# UNITED STATES PATENT AND TRADEMARK OFFICE

APPLICATION NO.	FILING DATE	FIRST NAMED INVENTOR	ATTORNEY DOCKET NO.	CONFIRMATION NO.
10/781,539	02/17/2004	Casey Chung	011687.00036	2451
22908	7590	12/01/2005	EXAMINER	
BANNER & WITCOFF, LTD. TEN SOUTH WACKER DRIVE SUITE 3000 CHICAGO, IL 60606			REHM, ADAM C	
			ART UNIT	PAPER NUMBER
			2875

<b>Office Action Summary</b>	Application No.	Applicant(s)	
	10/781,539	CHUNG, CASEY	
	Examiner	Art Unit	
	Adam C. Rehm	2875

## **DETAILED ACTION**

FIG. 1

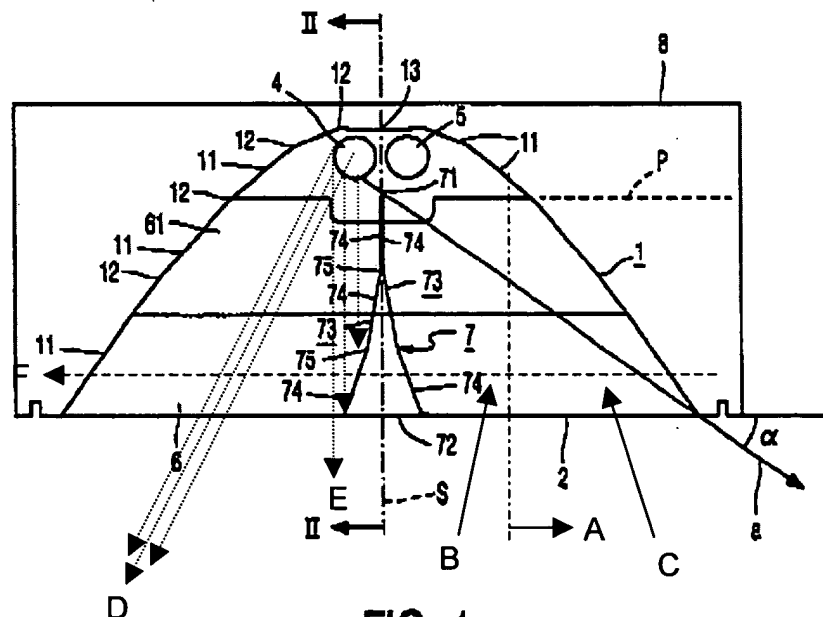
- Wherein each coverage zone has a light blocking area that blocks an amount of light (the side of 6 nearest the light has a width capable of blocking an amount of light; Fig. 1 below, Refs. D, E and F wherein Ref. D is illustrates no light blockage, Ref. E illustrates 66 percent light blockage; and Ref. F illustrates a linear path from (II) of blocked to unblocked light);

- Wherein the light blocking area is linear/provides a linear change in the percentage of light shielding/blocking along the first and second paths (6 blocks light and runs linear from the center (II) to the outer edge, Figs. 1 below, Refs. D, E and F; Fig. 2);

- Wherein the first path is an inner aperture (2) having first a first slope (74) configured to decrease the amount of light blocked along the first path (Ref. F illustrates a decrease in the amount of light blocked moving away from slope the left side of 74) and a second slope configured to increase the amount of light blocked moving toward the right side of 74 and along F);

- Wherein the center (II) that covers less than 90 percent (II, Fig. 1 covers less than 90 percent of the light source);
- Wherein the light shield comprises an outer aperture (2);

- A zone boundary located on the light shield between the center and the outer edge, wherein the first coverage zone is located between the center and the boundary and a second coverage zone is located between the boundary and outer edge, wherein the light blocking area of the first coverage zone is greater than the light blocking area of the second coverage zone, which linearly approaches/is zero light-blocking coverage (Ref. A below illustrates a zone boundary between two zones (B and C) wherein more light is blocked in the first zone relative to the second);
- A first angle displaced from the perpendicular angle providing more than/at least 60 degrees ( $\alpha$ , Fig. 1); and
- A second angle acts to limit light to less than 35 percent of the maximum (Ref. E, Fig. 1 below shows 33 percent of light to pass).
